To: Members of Dublin City Council
From: Dana L. McDaniel, City Manager 
Date: Tuesday, November 27, 2018
Initiated By: Vincent A. Papsidero, FAICP, Planning Director
Jennifer M. Rauch, AICP, Planning Manager
Re: Development Plan/Site Plan – Riverside Crossing Park, East Plaza, Phase 1 –
(Case# 17-124DP/SP)

17-124SPR
 Site Plan Review
 Riverside Crossing Park, Phase 1 - East Plaza

DUBLIN | RIVERSIDE CROSSING PARK
FINAL SITE PLAN

Re: Development Plan/Site Plan – Riverside Crossing Park, East Plaza, Phase 1 –
Update (Case#17-124DP/SP)

1 | EAST PLAZA WALL ELEVATION

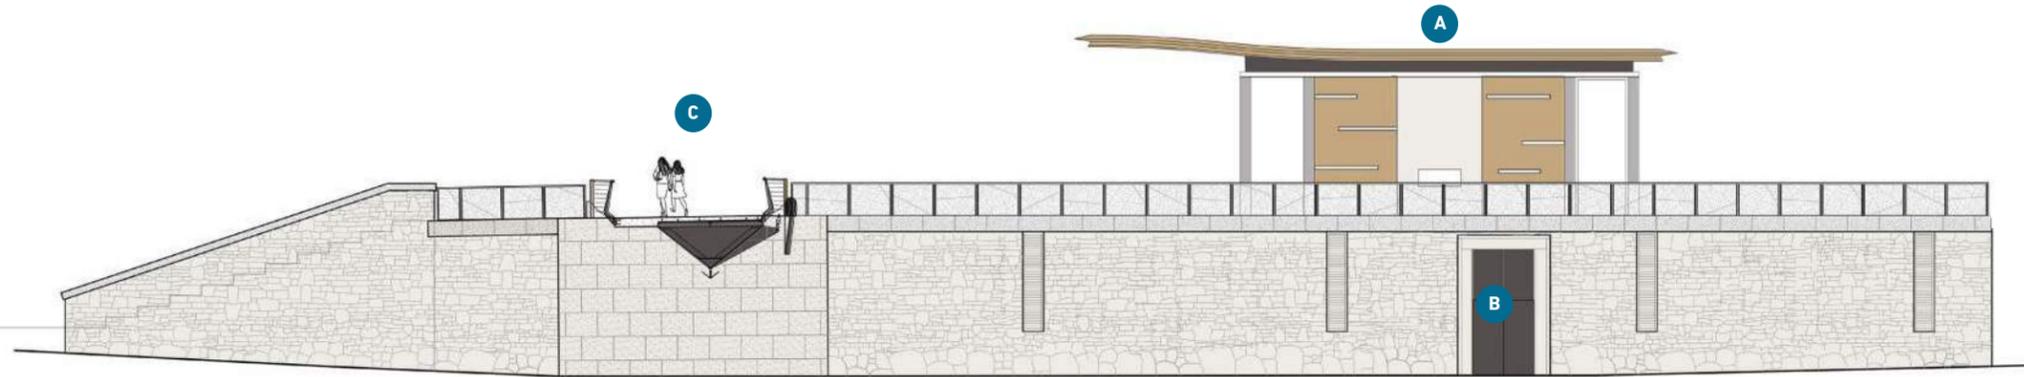
Council members expressed concerns about the 10-foot and 14-foot walls located along the western edge of the east plaza. The discussion focused on the rationale for the retaining walls, as well as the design, details and materials, and possible mitigation measures. The revised materials include the approved plans and section views from the 2016 Basic Plan for this area, showing the grade changes in relation to the plaza, bridge abutment, and the path under the bridge.

1. Provide an overview of the key steps and timeline in the public planning and engagement process for the River Crossing Park.
2. Address concerns raised about the 10-foot and 14-foot walls located along the western edge of the east plaza.
 - a. Provide additional graphics and information related to the design, rationale for, and possible mitigation measures associated with the 10-foot and 14-foot walls.

- b. Provide additional details regarding the design and quality of the railing at the top of the 10-foot retaining wall.
 - c. Provide real cut stone on 14-foot east-facing plaza wall.

The proposed design of the exterior of the utility room under the plaza incorporates the limestone design that is consistent with the design shown at the time of the approved Basic Plan. The vehicular entrance to the utility room has been relocated to minimize the visual impact from the pedestrian bridge.

F | EAST LAWN E/W SECTION

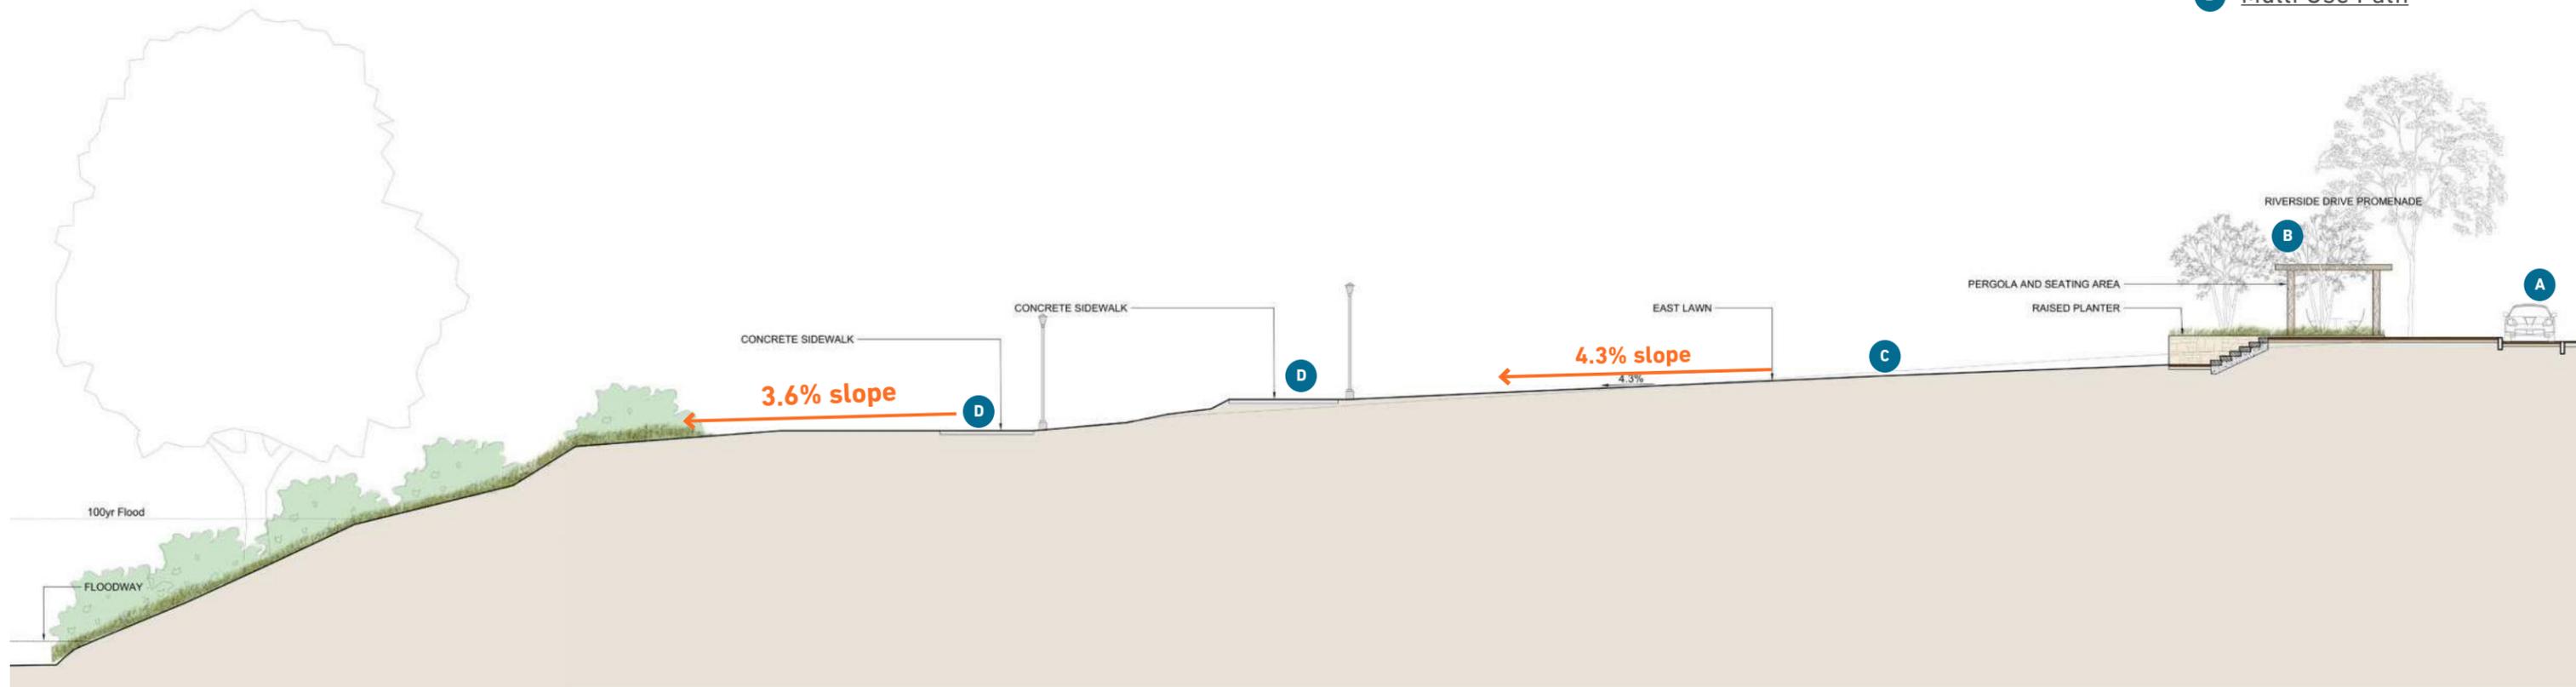
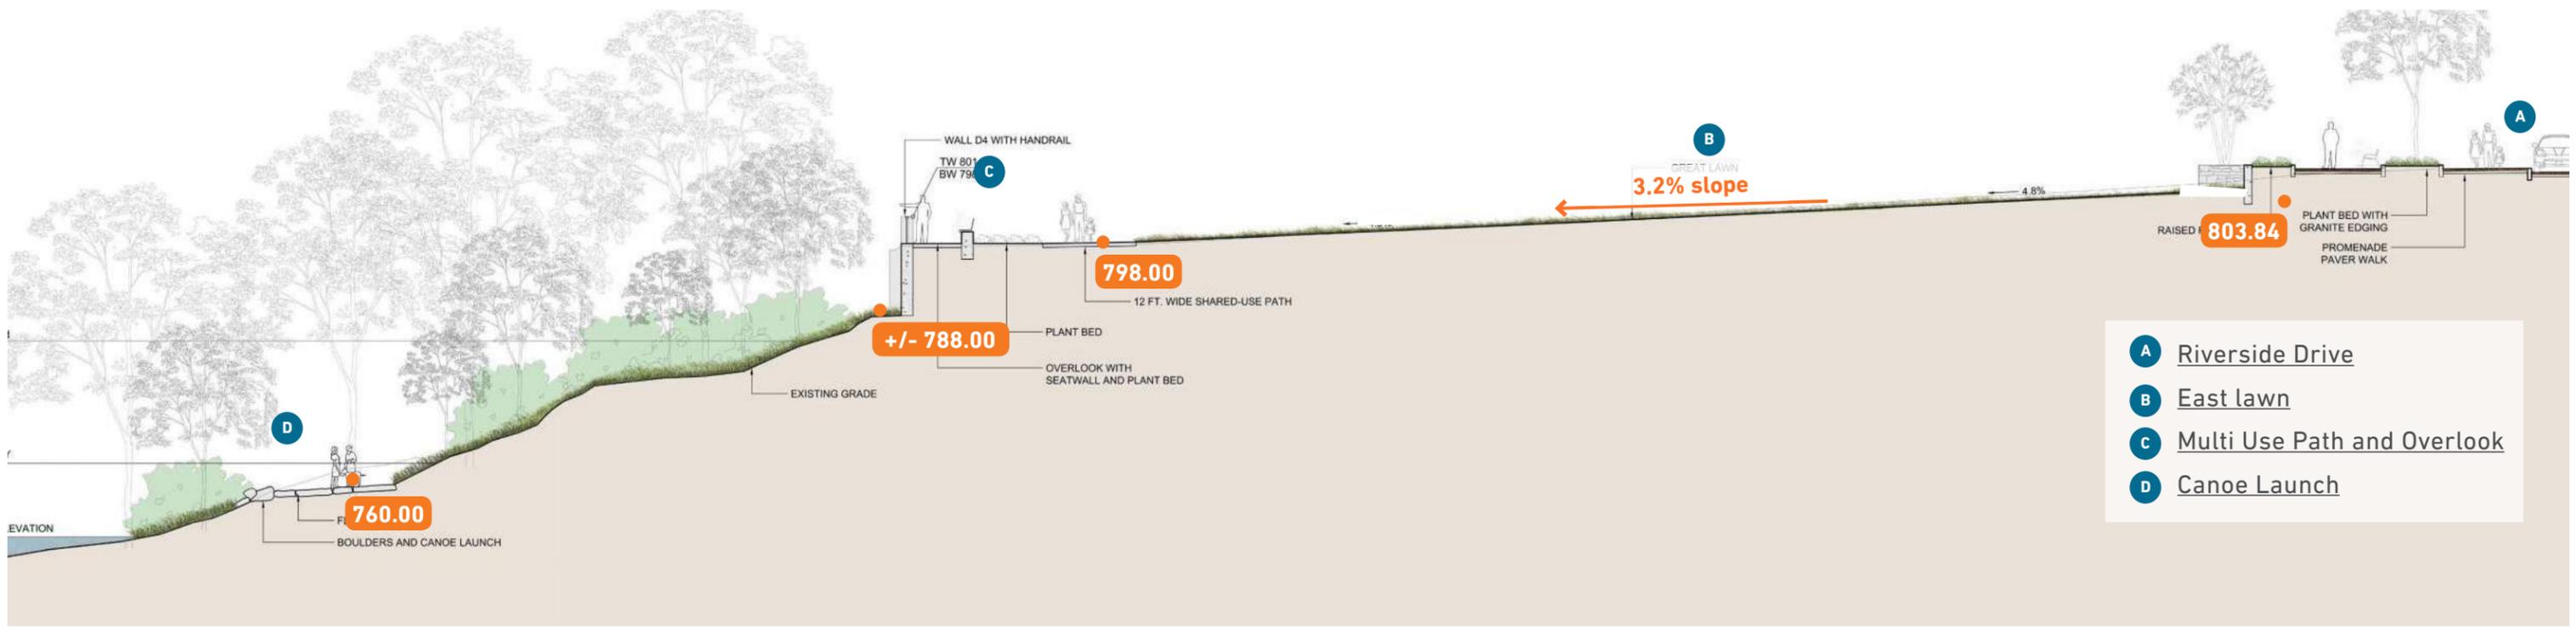
5. Provide an additional view from the south looking north.
6. Clarify the slope and cross section at the lawn area. Provide cross sections throughout this lawn area.

Council members requested additional information regarding the slope and cross section at the lawn area. The materials include information previously provided with the approved Basic Plan showing the change in grade within the lawn area. The materials included comparable grading information to other local parks for reference, as well as the existing and proposed topography on the site. The maximum slope indicated in the final Development and Site Plans is 3.2 to 3.6 across the lawn area, which is consistent with the approved Basic Plan.
